Product Change Notification: PCN-26-283223

Type III contacts and Posted connector assemblies

Plating Condition Descriptions Resulting from Product Change

Functional Plating Interface between Pin & Socket

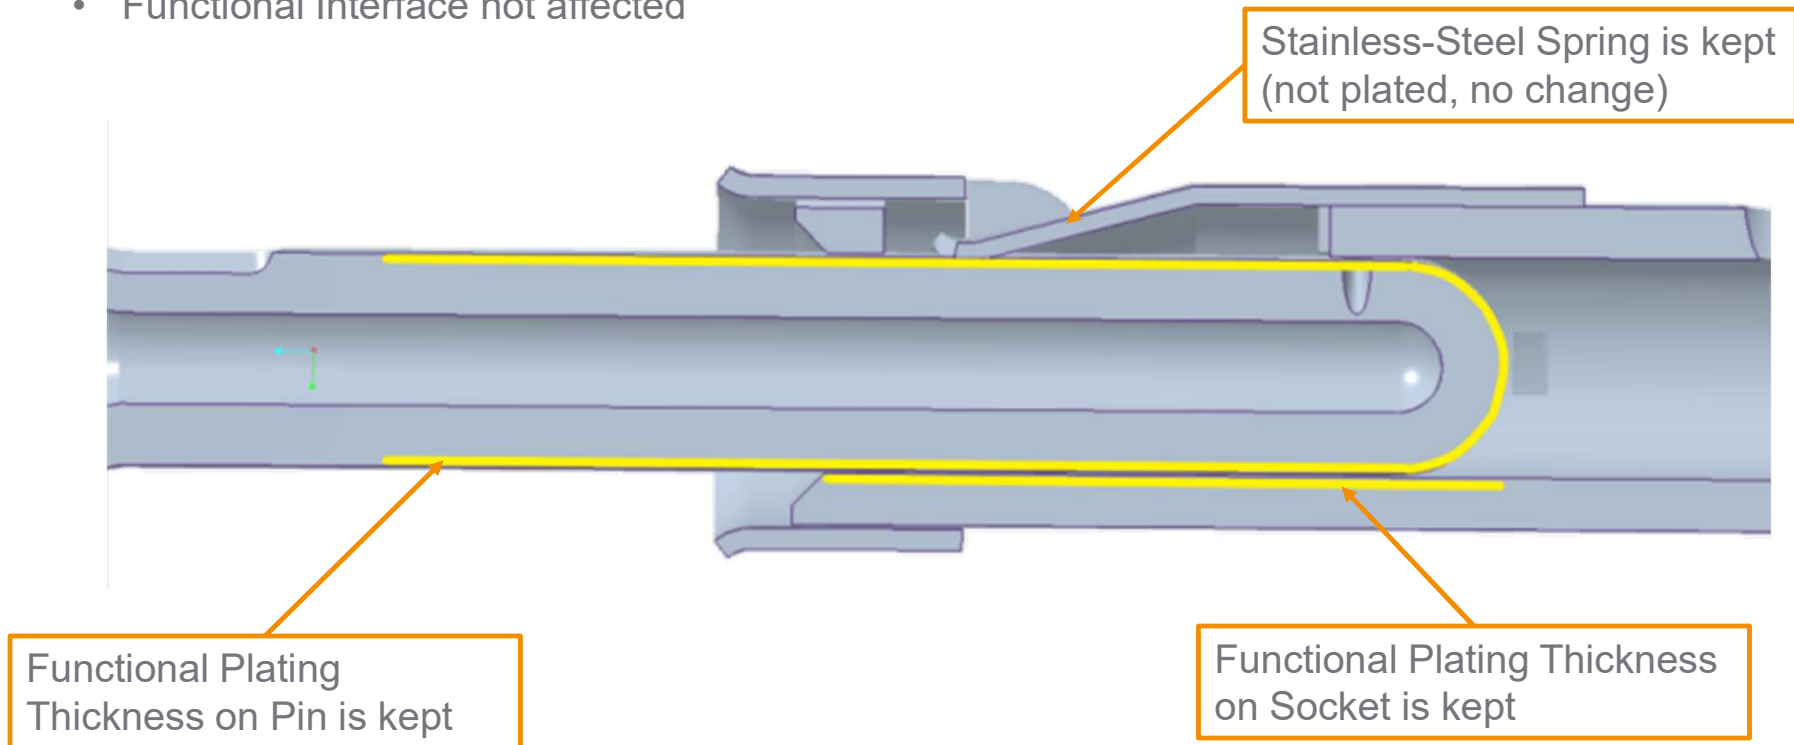
Functional area [mating interface] plating not affected
Matte Tin on crimp area
All over Nickel

Functional area [mating interface] plating not affected
Gold Flash on contact body
Matte Tin on crimp area
All over Nickel

Functional area [mating interface] plating not affected
Gold Flash on the remainder
All over Nickel

Functional (mating interface) plating thickness specific to each PN is not affected by this product change.
50 μ m minimum Matte Tin isolated to crimp area.
75 μ m Nickel all over and as an underplate to Au and Tin

- Functional Interface not affected
